City of Portland, Maine – Building or Use Permit Application 389 Congress Street, 04101, Tel: (207) 874-8703, FAX: 874-8716

Location of Construction: 17 Eighth Maine Ave, Peaks Isl		Owner: Desousa, Robert & Annette		Phone: 766-2175		Permit No: 960553	
Owner Address: SAA 04108		Leasee/Buyer's Name:		Phone:		Business Name:	
Contractor Name: Cottage Renovations		Address:		Phone:		Permit Issued: JUN 19 1996 CITY OF PORTLAND	
Past Use: 1-122		Proposed Use: Same		COST OF WORK: \$ 450.00 PERMIT FEE: \$ 25.00 FIRE DEPT. <input type="checkbox"/> Approved <input type="checkbox"/> Denied INSPECTION: Use Group: Type:		Zone: CBL: 085-N-012 Zoning Approval: Special Zone or Reviews: <input type="checkbox"/> Shoreland <input type="checkbox"/> Wetland <input type="checkbox"/> Flood Zone <input type="checkbox"/> Subdivision <input type="checkbox"/> Site Plan <input type="checkbox"/> maj <input type="checkbox"/> minor <input type="checkbox"/> mm <input type="checkbox"/>	
Proposed Project Description: Install Skylight Remove/Enlarged Window		PEDESTRIAN ACTIVITIES DISTRICT (P.U.D.) Action: <input type="checkbox"/> Approved <input type="checkbox"/> Approved with Conditions <input type="checkbox"/> Deni

Skylite framing 24" skylite set into
 Existing Rafters 25 o.c. headed off w/ doubled
 2x4 All existing framing
 is 2x4 stock
 Approximate cost \$2500⁰⁰

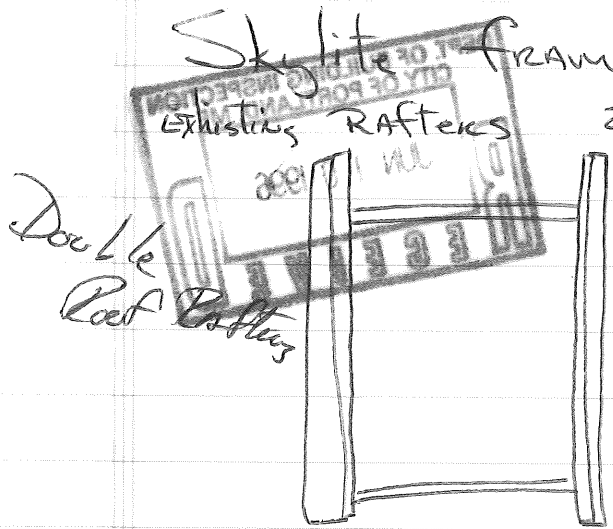
1. This permit is being issued with the understanding that the existing rafters will not be cut .
2. The proposed skylight glass shall meet the requirements of section 2404.0 of the city's building code (THE BOCA NATIONAL BUILDING CODE /1993) .
